UNITED STATES PATENT AND TRADEMARK OFFICE

APPLICATION NO.	FILING DATE	FIRST NAMED INVENTOR	ATTORNEY DOCKET NO.	CONFIRMATION NO.
10/791,101	03/02/2004	Shimshon Gottesfeld	107044-0043	2480
24267	7590	09/22/2008		
CESARI AND MCKENNA, LLP 88 BLACK FALCON AVENUE BOSTON, MA 02210			EXAMINER CANTELMO, GREGG	
			ART UNIT	PAPER NUMBER
			1795	
			MAIL DATE	DELIVERY MODE
			09/22/2008	PAPER

Office Action Summary	Application No. 10/791,101	Applicant(s) GOTTESFELD ET AL.	
	Examiner Gregg Cantelmo	Art Unit 1795

DETAILED ACTION

FIG. 4

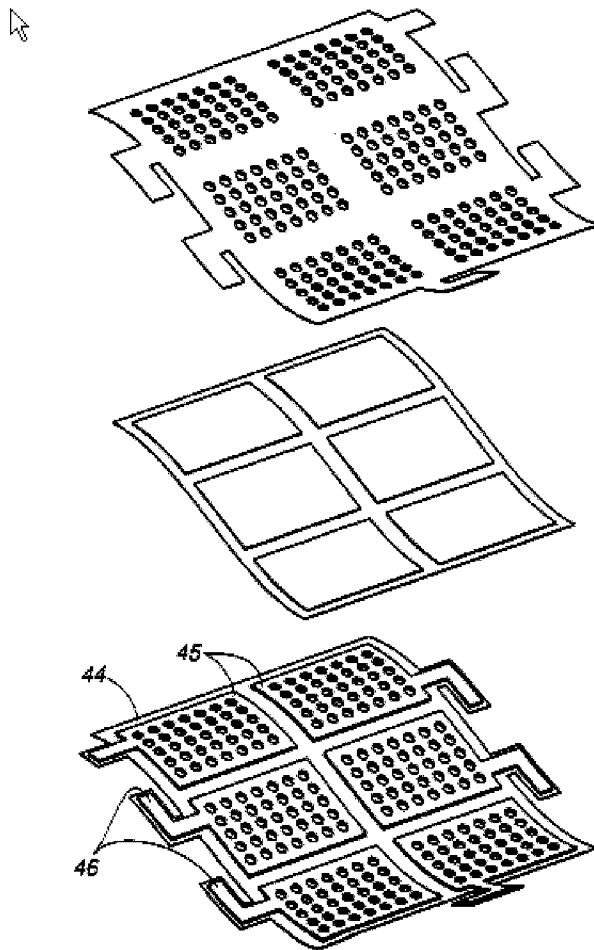
Pratt discloses a conformable fuel cell in Fig. 4, comprising: (A) a membrane electrolyte intimately interfacing with a catalyst layer along each of the membrane's major surfaces being a catalyzed membrane electrolyte, having an anode aspect and a cathode aspect, and which catalyzed membrane electrolyte is flexible (e.g., conformable to a plurality of desired shapes); (B) diffusion layers sandwiching said catalyzed

membrane electrolyte, said diffusion layers being comprised of materials that are conformable; (C) flexible current collectors coupled with each of said anode aspect and said cathode aspect of said membrane electrolyte; (D) fuel delivery means coupled with said anode aspect of said membrane electrolyte that delivers fuel substantially uniformly to said anode aspect while said fuel cell maintains said desired shape (Figs. 2-5); (E) a fuel cell housing including a plastic frame 24 which corresponds to the desired shape of the fuel cell array and maintains compression along the fuel cell array (Figs. (E) electrical coupling 45 disposed across said anode aspect and said cathode aspect and having means for connection to an application device being powered by said fuel cell (as applied to claim 1).

The current collectors 45 at each of said anode aspect and said cathode aspect apply “adequate compression” effectively over the active area of the membrane electrolyte of each cell (Fig. 4 as applied to claim 2)

The fuel cell in Fig. 4 is shaped to form a curvilinear shape (col. 5, ll. 25-28 as applied to claim 12).

Pratt discloses a conformable fuel cell in Fig. 4, comprising: (A) a membrane electrolyte intimately interfacing with a catalyst layer along each of the membrane's major surfaces being a catalyzed membrane electrolyte, having an anode aspect and a cathode aspect, and which catalyzed membrane electrolyte is flexible (e.g., conformable to a plurality of desired shapes); (B) diffusion layers sandwiching said catalyzed membrane electrolyte, said diffusion layers being comprised of materials that are conformable; (C) flexible current collectors coupled with each of said anode aspect and said cathode aspect of said membrane electrolyte; (D) fuel delivery means coupled with said anode aspect of said membrane electrolyte that delivers fuel substantially uniformly to said anode aspect while said fuel cell maintains said desired shape (Figs. 2-5); (E) a fuel cell housing including a plastic frame 24 which corresponds to the desired shape of the fuel cell array and maintains compression along the fuel cell array (Figs. (E) electrical coupling 45 disposed across said anode aspect and said cathode aspect and

The claims have been amended whereby the changes to element D of claim 1 and the introduction of additional element E now claim a structure which is held to be taught by Pratt alone. Notably, Pratt discloses a fuel delivery element for delivering fuel

to the anode and also employs a fuel cell housing including a plastic frame 24 wherein the housing, which corresponds to the planar shape of the fuel cell array aids in compression of the fuel cell elements to maintain the requisite physical contact between the electrodes and electrolyte of the fuel cell array.
